Toscano Wyeth Ranch LMA Turf Conversion

PROJECT: (update to DS 2954)

CITY OF LAS VEGAS INTER-OFFICE MEMORANDUM		DATE: March 13, 2013
TO: Land Development Services Department of Public Works		FROM: Albert Sung, P.E. Flood Control Project Engineer Department of Public Works
SUBJECT:	Drainage Study for: Toscana Wyeth Ranch LMA Turf Conversion (Update to DS2954)	
Cross Streets:	SWC of Rainbow Blvd. & Farm Rd.	Toscana-Wyeth Ranch Landscape Maintenance Association
File Number:	F:\Depot\DSMemos\DS4579B.doc	Bart Anderson, P.E., DevCo
Parcel Number:	125-15-7797-001	
Zoning Action:	N/A	
FEMA Flood Zone	YES NO X	
Proposed Storm Drain	YES NO X

REMARKS: Drainage Study in support of reducing turf area above channel freeboard.

XERISCAPE CONVERSION
PLANTING PLAN

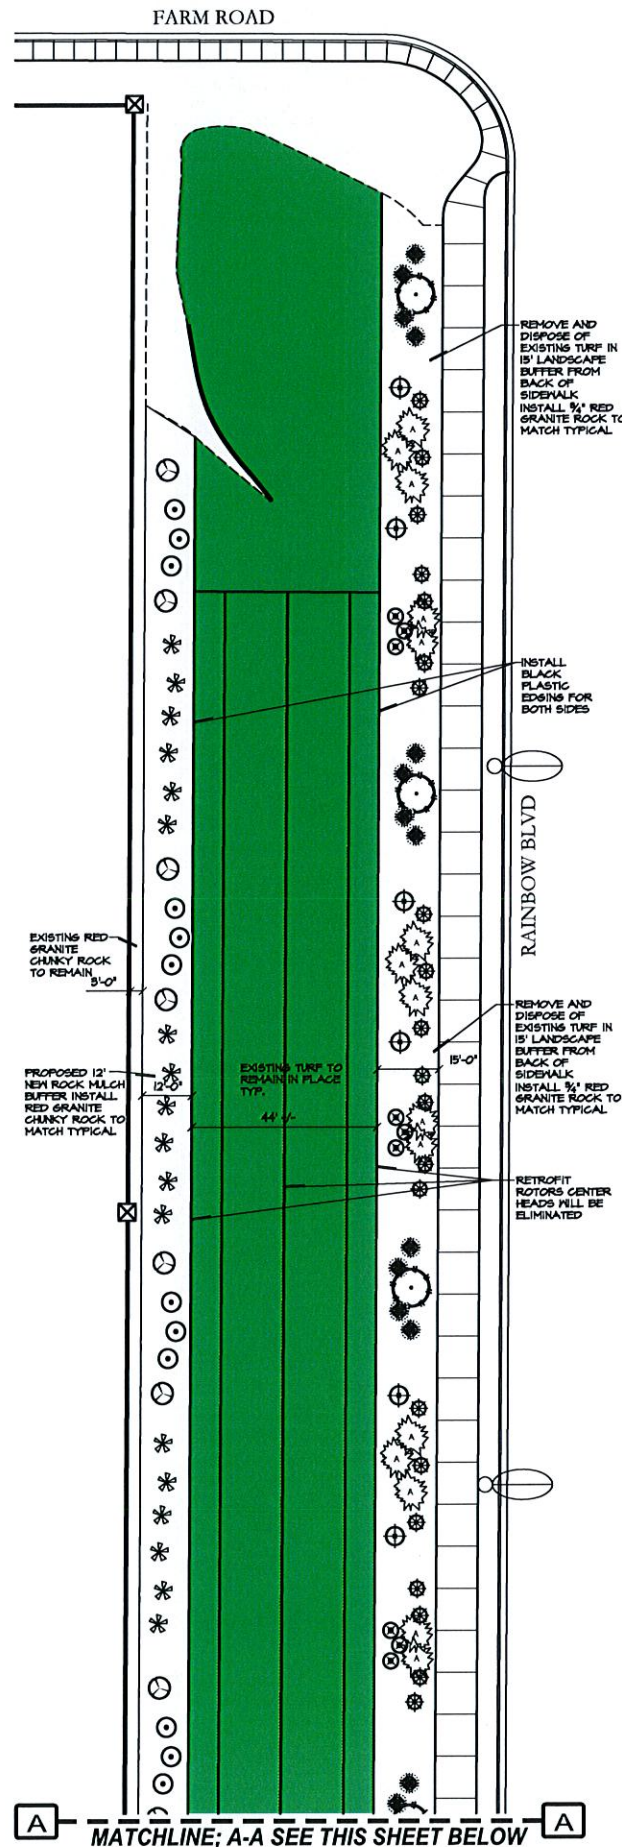
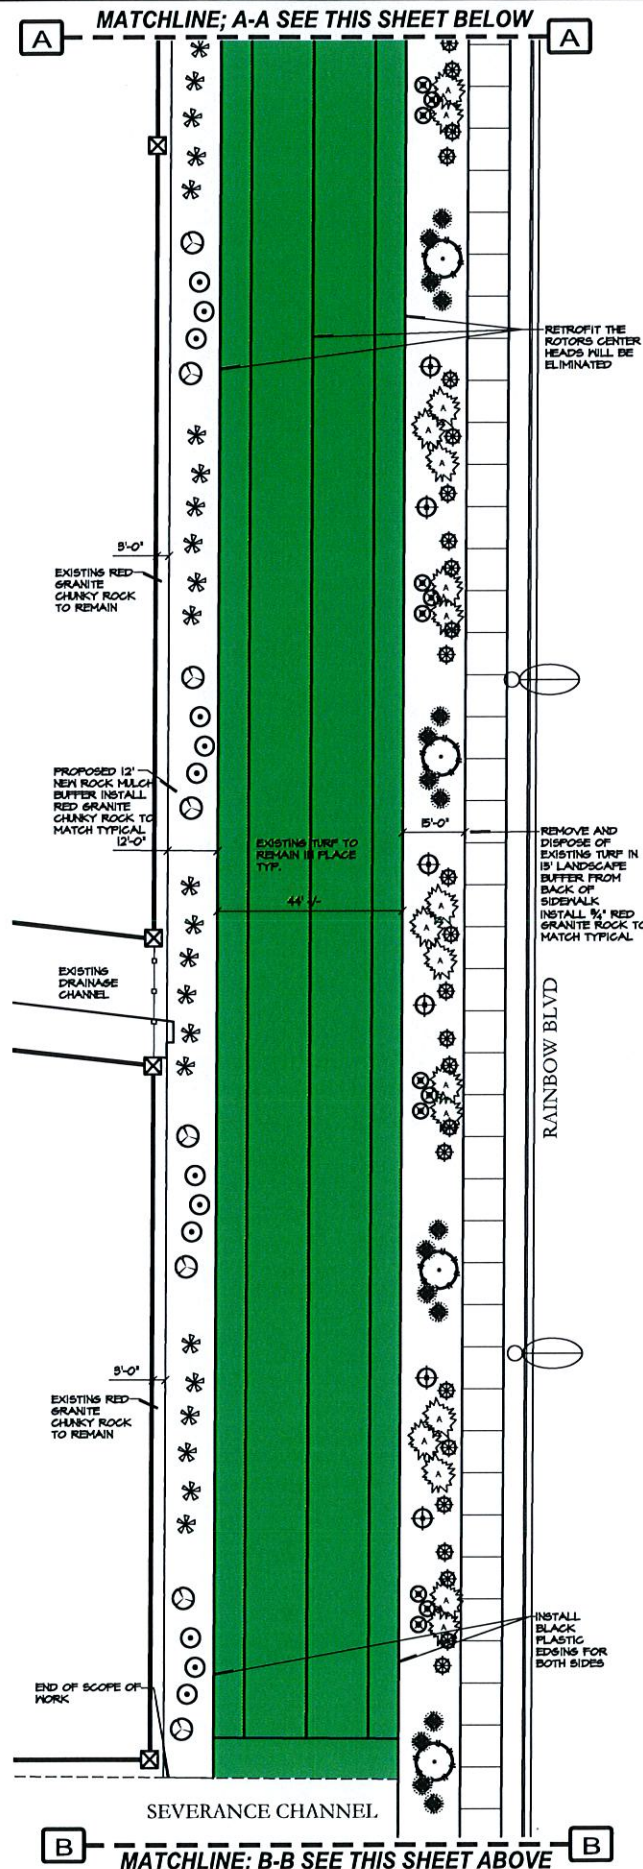
3. The Landscape plans by Jaramillo Landscape need to be revised to include a cross section of the channel area that shows the minimum channel depth to top of turf area per the recommendations of this study.

- Rainbow Channel between Farm Rd. & Severance Channel - 2.5' above channel bottom.
 - Rainbow Channel between Severance Channel & MPU facility - 3.5' above channel bottom.

- Severance Channel between Tenaya Rd. & Rainbow Channel - 4.0' above channel bottom.

SHEET **6** OF 10
C.L.V. DWG.#

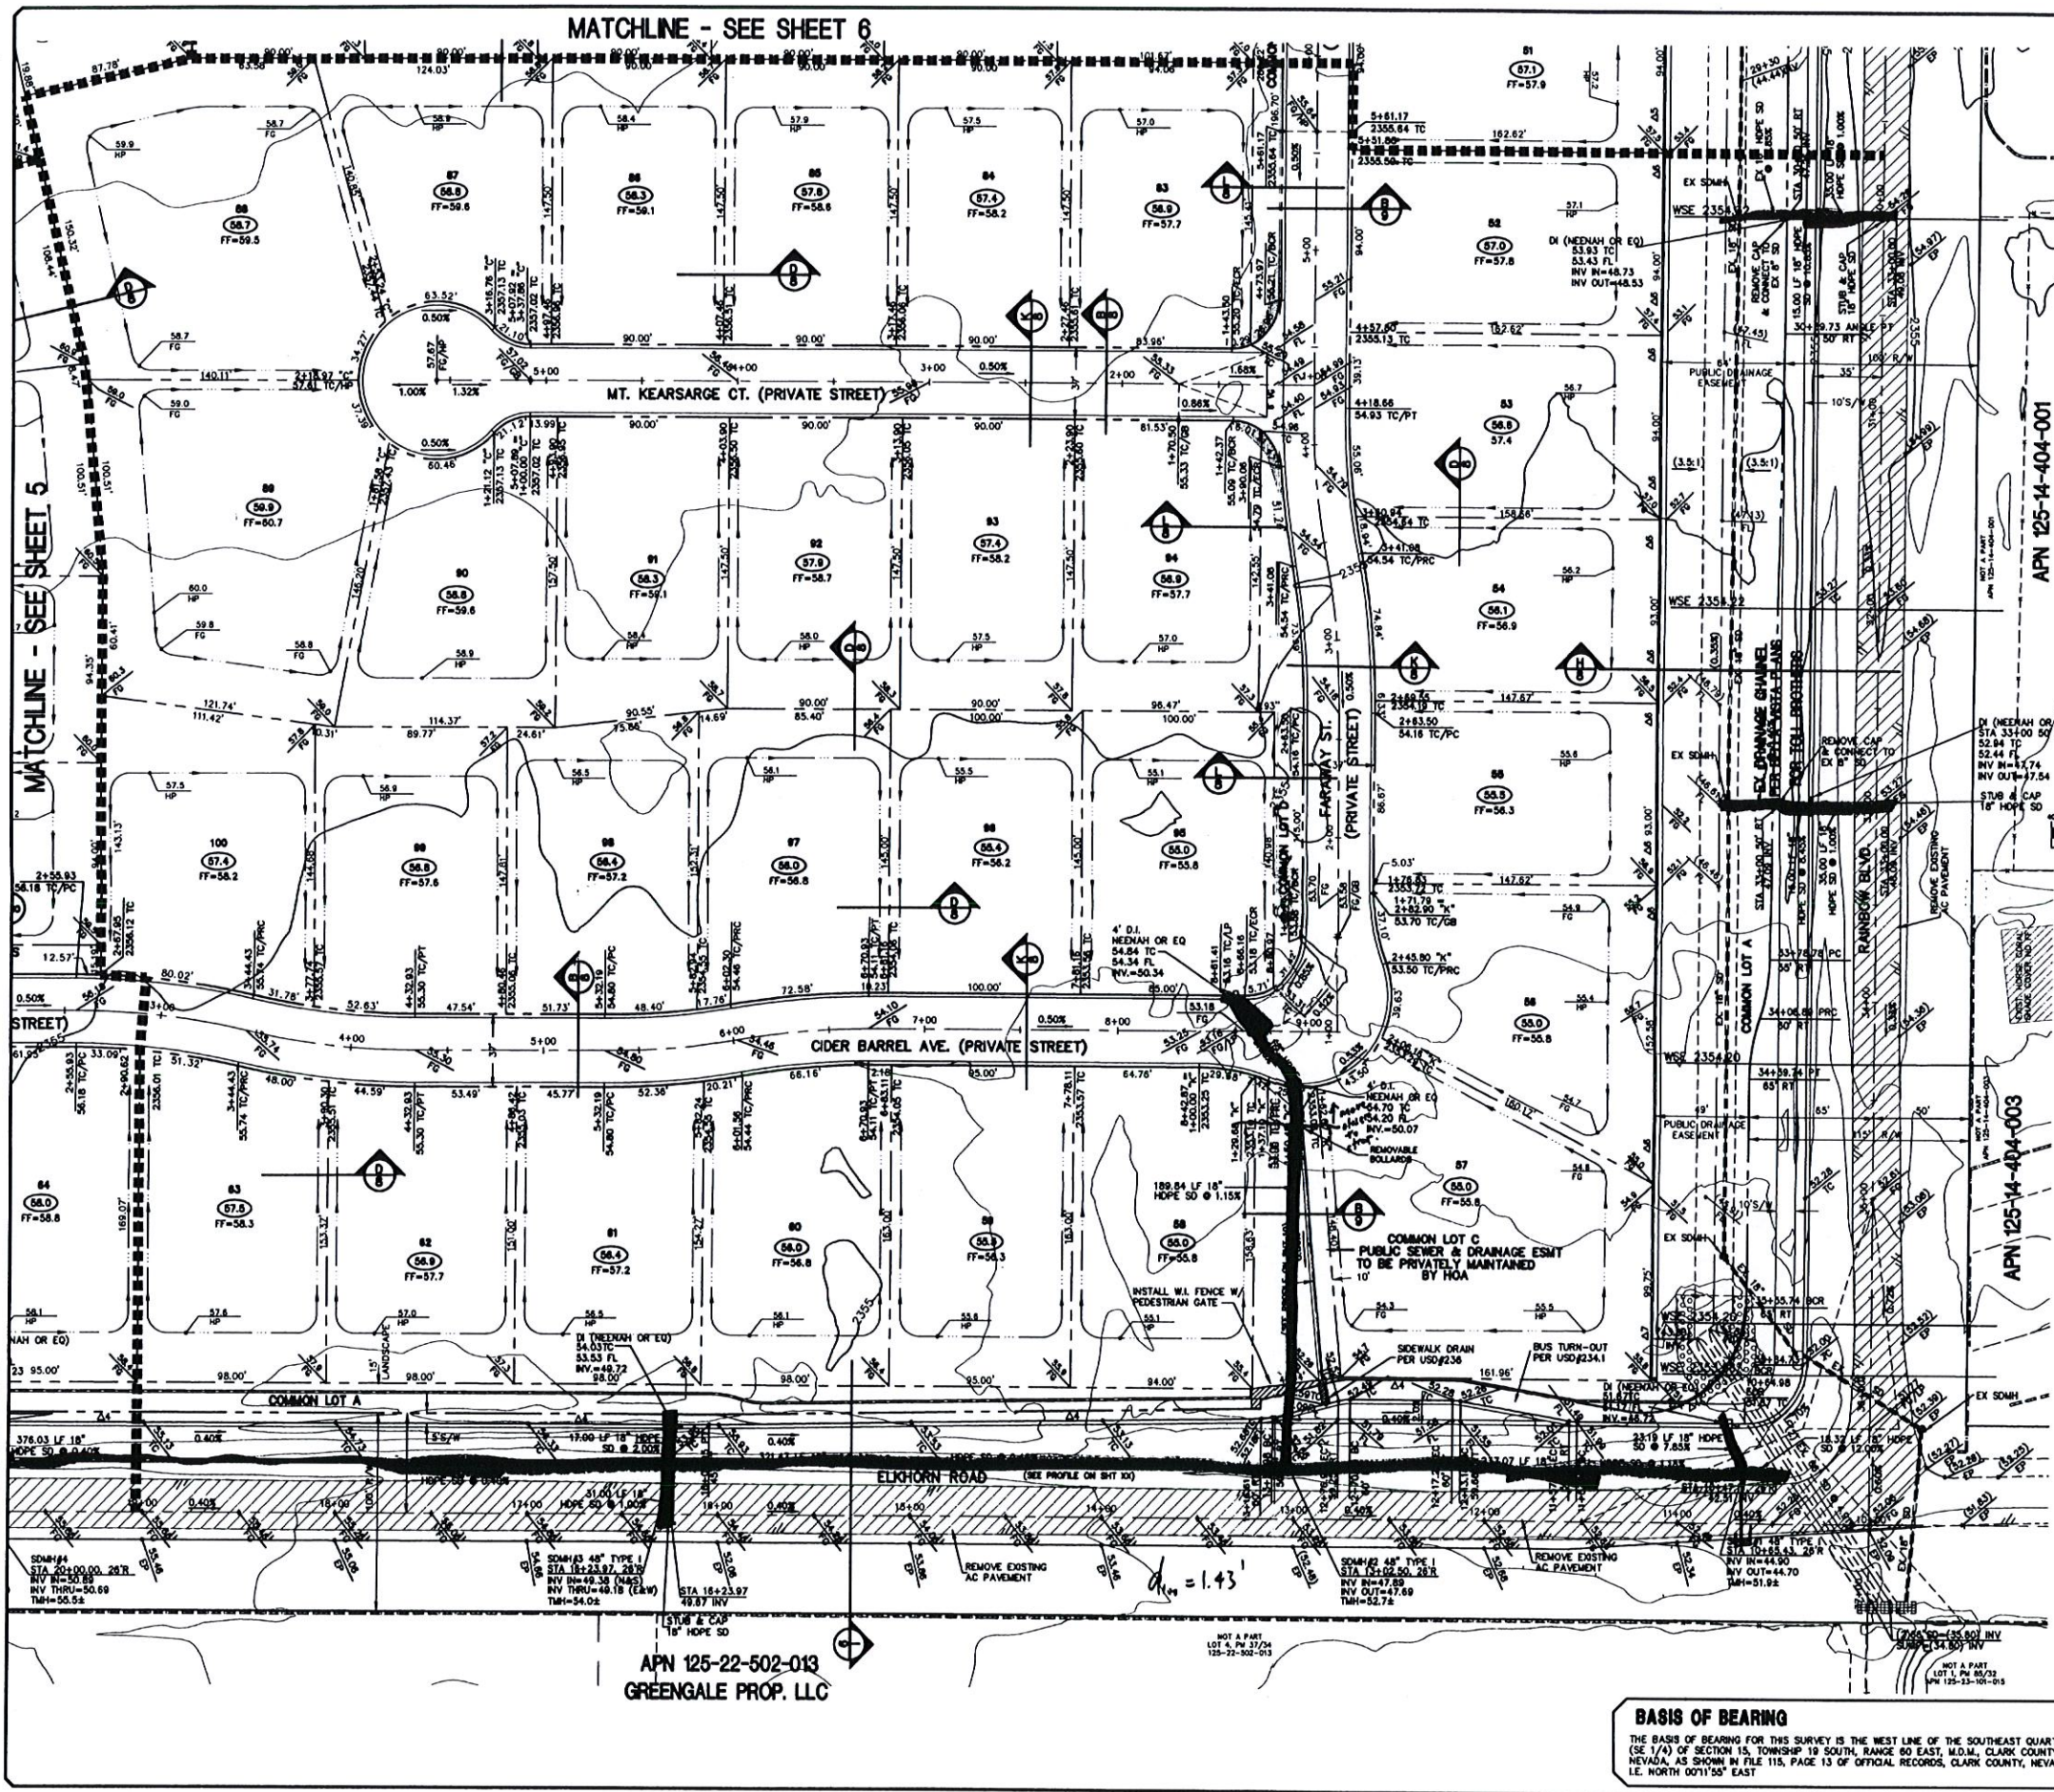
5. Per previous comment #7: *The stem wall adjacent to the sidewalk must be shown to provide 8" CMU solid grouted to 2 courses above the back of walk. Revise details I/8 and I/9 accordingly.*
6. Sheet 6: Provide 18" lateral at the drop inlet in the intersection of Severance channel and Rainbow Boulevard to pass centerline of Rainbow.
